Access Compliance Report

Public Rights-of-Way

(Curb Ramps)

Intersection ID: 48216	Main Street: BERRY_MILLER_CT	Cross Street: ABERGLEN_DR	Location:	N
ADA ID: D234445B96AD	Ramp Type: PerpDiag	Initial Pass/Fail: Fail	Overall Compliance: No	Severity Score: 8.75
Codes/Mitigation Info/Possible Solution		Field Measurements/Component Compliance

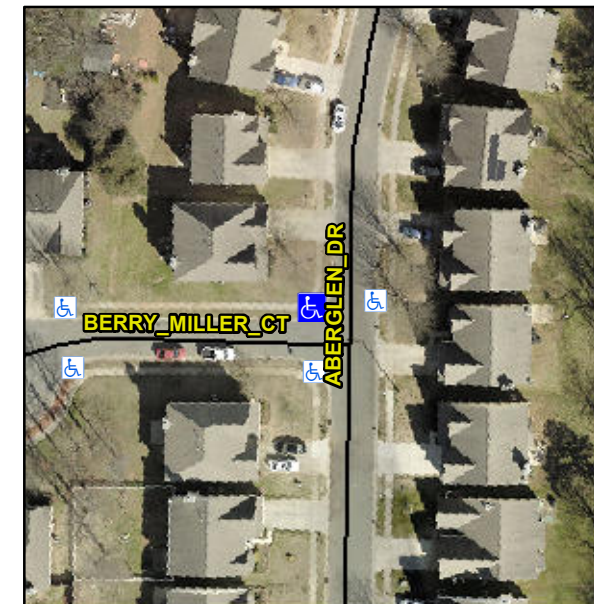
Not Found, R304.5.1

Compliance	Description	Data	Compliance	Description	Data
N/A	Ramp Length (in)	48.0	Yes	Ramp Slope (%)	8.1
No	Ramp Width (in)	47.0	Yes	Ramp XSlope (%)	0.6
N/A	Flare Type LT	N/A	N/A	Flare Type RT	N/A
N/A	Flare Slope LT (%)	N/A	N/A	Flare Slope RT (%)	N/A
N/A	Flare Traversable LT?	N/A	N/A	Flare Traversable RT?	N/A
N/A	Landing Length (in)	N/A	N/A	DWS Provided?	N/A
N/A	Landing Width (in)	N/A	N/A	DWS Contrast?	N/A
N/A	Landing Slope (%)	N/A	N/A	DWS Length (in)	N/A
N/A	Landing X Slope (%)	N/A	N/A	DWS Full Width?	N/A
N/A	Landing Curb? (Y/N)	N/A	N/A	DWS Offset (in)	N/A
N/A	Shared Landing?	N/A			
N/A	Gutter Ponding?	N/A	N/A	Gutter Slope (%)	N/A
N/A	Gutter Lip Ht (in)	N/A	N/A	Gutter X Slope (%)	N/A
N/A	Painted X Walk1?	No	N/A	Painted X Walk2?	No
	X Walk 1 Direction	To W		X Walk 2 Direction	To E
N/A	X Walk 1 Width (in)	N/A	N/A	X Walk 2 Width (in)	N/A
	X Walk 1 Slope (%)	4.0		X Walk 2 Slope (%)	6.5
	X Walk 1 X Slope (%)	14.0		X Walk 2 X Slope (%)	6.9

N/A	Ramp inside XWalk1?	N/A	N/A	Ramp inside XWalk2?	N/A
	Road Slope (%)	1.8	N/A	Clear Space?	N/A
	Road X Slope (%)	4.9	N/A	Clear Space to XWalk (in)	N/A
N/A	Any Obstructions?	N/A	N/A	Storm Grate/Utility Hazard?	N/A
	Obstruction Type			Storm Grate/Utility Type	
		N/A			N/A
			Yes	Surface Condition? (G/P)	Good

Remove & Replace Curb Ramp With Two New Directional Ramps or Equivalent.
